Secretary Matthew Beaton
Executive Office of Energy and Environmental Affairs
Attn. MEPA office
Alexander Strysky
EEA # 15278
100 Cambridge Street, suite 900,
Boston MA 02114

Thank you for the opportunity to comment on the I-90 Allston Interchange project. We are submitting these comments on behalf of the Charles River Conservancy (CRC).

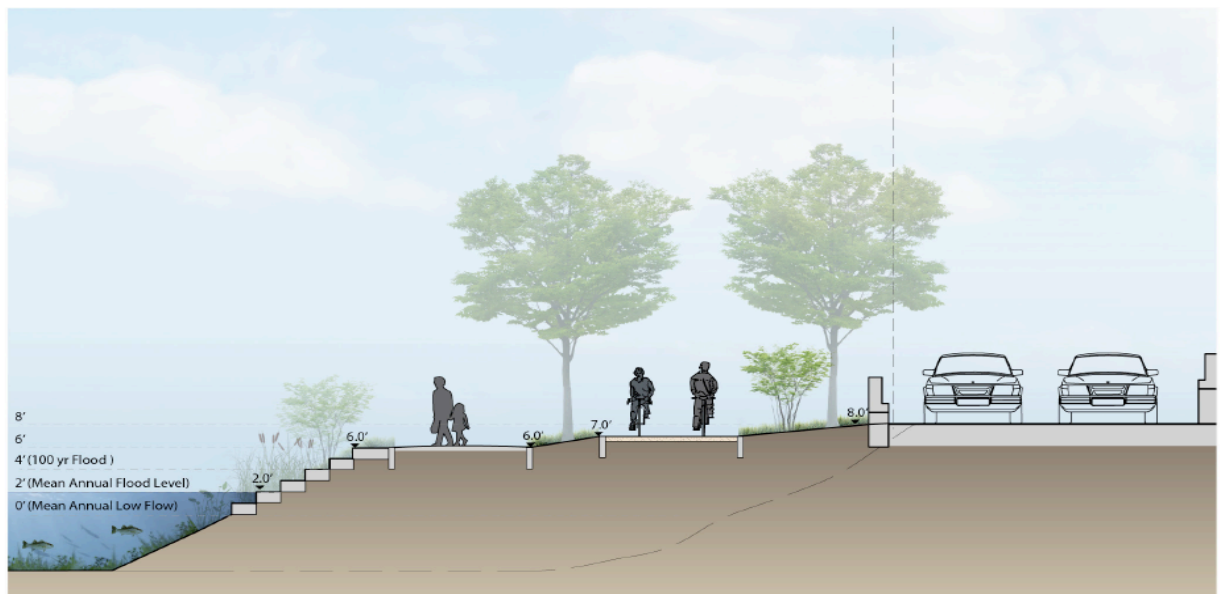
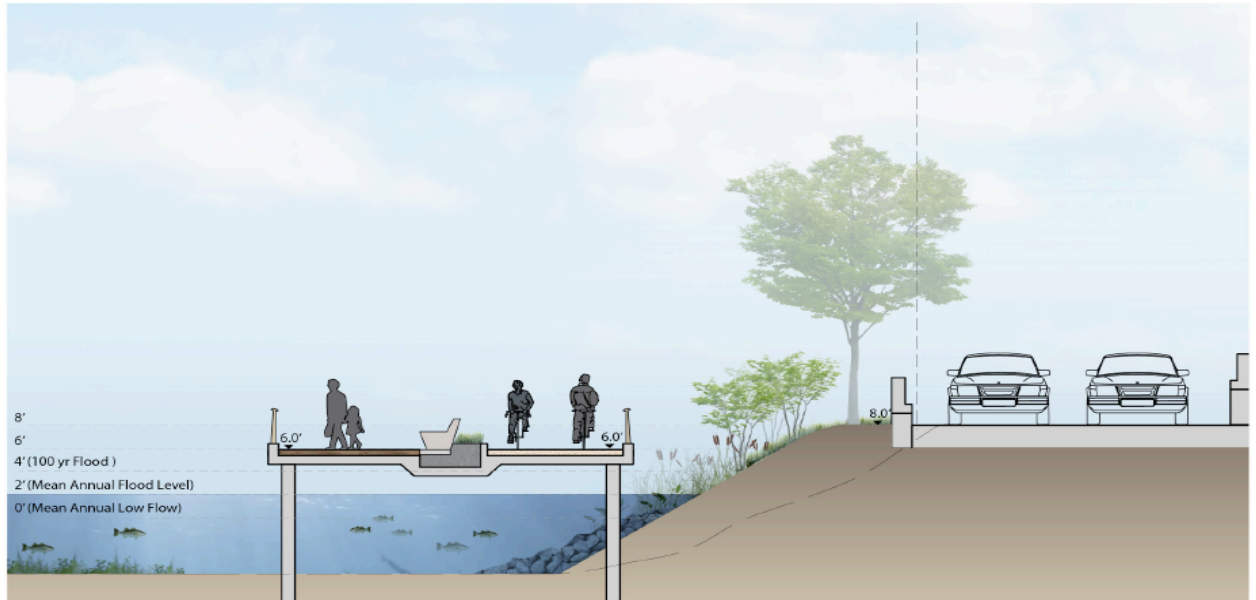
Design goals have been promulgated by the DCR for riverfront paths with separate paths for pedestrians and bikes are already in existence.

- In conflict with such goals, a substantial portion of the riverfront known as the "throat" co-mingle both pedestrians and bicycles in one path.
- Dual path systems are found both upriver and downriver from the throat portion of the I-90 project.
- The Esplanade Association and DCR are working toward separating bike and walking/running paths between the Science Park Dam and the BU Bridge
- Two miles of dual riverfront paths have been rebuilt along Memorial Drive in Cambridge.
- The I-90 project has already designed a two-acre riverfront park along Soldiers Field Road with dual paths.

3K-ABC Alternative 2A

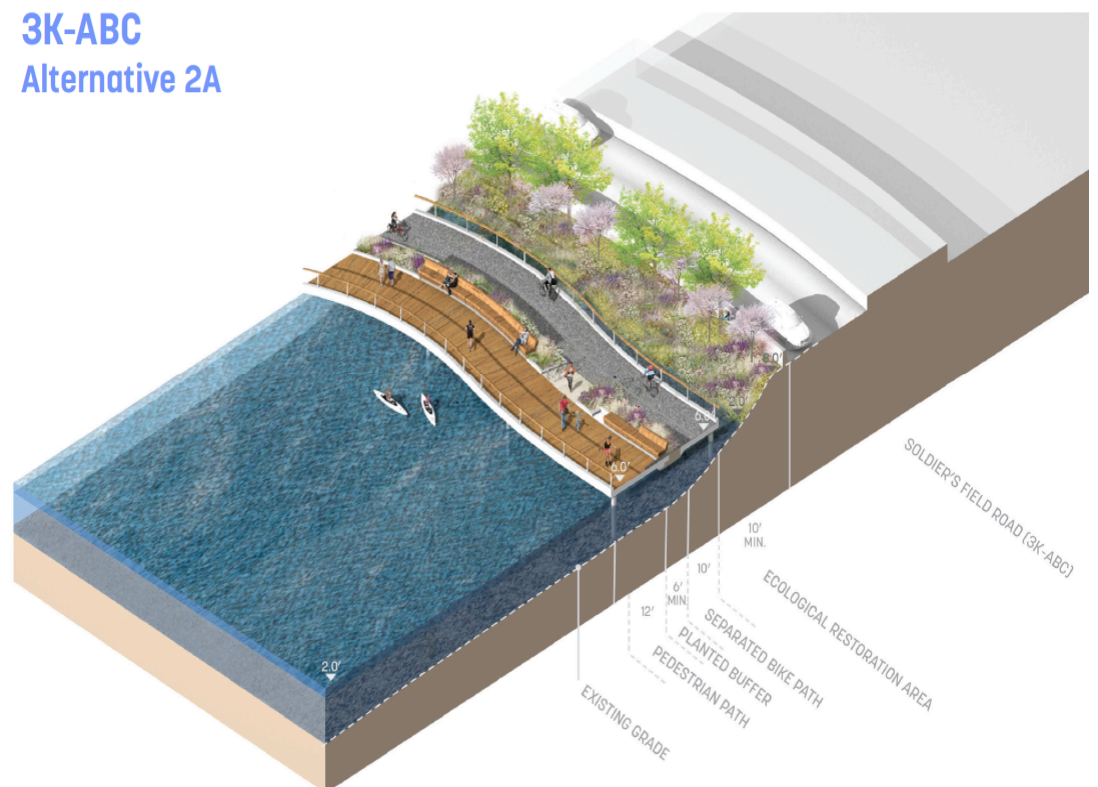
This recommendation from the Charles River Conservancy and WalkBoston for either the boardwalk or the expanded shoreline proposals are superior to the currently proposed, narrow and unsafe walkway.

Proposed single path with the highway viaduct option

Proposed dual paths with the expanded shoreline option
